GOLD STANDARD VERIFICATION REPORT

For: CO2balance UK Ltd

REPORT NO.:
GS5329-32-MP6
GS5335-44-MP6
GS5437-41-MP6

Related activity	Verification
Project Title (s)	1. GS1247 VPA 91 Improved Kitchen Regimes Multi-Country PoA - Dowa Boreholes, Malawi (GS5329) 2. GS1247 VPA 92 Improved Kitchen Regimes Multi-Country PoA - Dowa Boreholes, Malawi (GS5330) 3. GS1247 VPA 93 Improved Kitchen Regimes Multi-Country PoA - Dowa Boreholes, Malawi (GS5331) 4. GS1247 VPA 94 Improved Kitchen Regimes Multi-Country PoA - Dowa Boreholes, Malawi (GS5332) 5. GS1247 VPA 95 Improved Kitchen Regimes Multi-Country PoA - Dowa Boreholes, Malawi (GS5335) 6. GS1247 VPA 96 Improved Kitchen Regimes Multi-Country PoA - Dowa Boreholes, Malawi (GS5336) 7. GS1247 VPA 97 Improved Kitchen Regimes Multi-Country PoA - Dowa Boreholes, Malawi (GS5337) 8. GS1247 VPA 98 Improved Kitchen Regimes Multi-Country PoA - Dowa Boreholes, Malawi (GS5338)

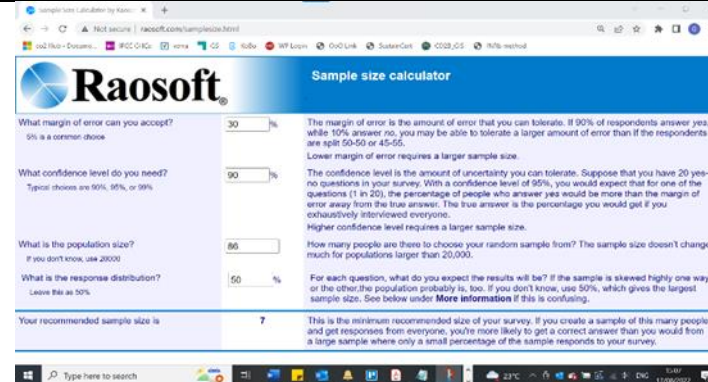
Rule	Assessment Question	Findings/Comments (CL 11)	Developer Response
	For any parameters that were sampled, has the following been demonstrated: (a) Description of implemented sampling design; (b) Collected data; (c) Analysis of the collected data; (d) Demonstration that the required	Section D.4. 1. The PD is required to provide all the randomly generated numbers selected from the list of boreholes listed in the Excel sheet. 2. The PD must ensure that for any parameters subjected to sampling, the following aspects are demonstrated: ○ Description of the implemented sampling design ○ Details of the collected data	1) PD has provided random numbers on sheet 'Final Selection' in excel 'Malawi P1_2_5 Random Sample 2022 process'. Please note there are multiple of each random number due to the sampling process of selecting boreholes from different age groups. The sheet 'Final Selection (for UP)' does not have the random numbers as this is the same list as the previous sheet but organized by village for convenience for the partner. 2) The sampling design can be seen in the excel 'Malawi P1_2_5 Random Sample 2022 process'.

Rule	Assessment Question	Findings/Comments (CL 11)	Developer Response
	confidence/precision level has been met; Demonstration that the samples were randomly selected and are representative of the population	○ Analysis of the collected data ○ Demonstration of meeting the required confidence/precision level ○ Verification that the samples were randomly selected and are representative of the population. 3. For monitoring parameters where sampling is necessary, the PD is required to demonstrate compliance with the required confidence/precision level as per the methodology. This demonstration should be documented in Section D.4 of the MR.	The description of data collection is set out in Section C of the MR – 'Of the monitoring surveys, the project and usage surveys were collected using remote data collection. The Water Consumption Field Test was conducted on paper. All results are collated in excel spreadsheets and stored in an electronic format. Paper copies of the WCFT are stored in UP's office for this project.' Collected data and accompanying analysis is given in the excels for US, PS and WCFT. As the VPAs are homogeneous, cross sampling of devices was applied, so even though there are not households for each VPA/BH in the samples, those in the sample are representative of the population. The boreholes are first divided into age groups, to ensure a representative sample from each age group of project technology. The boreholes in each age group are assigned a random number and a 90/30 confidence precision is used to select a representative number of boreholes from each age group. See example below.
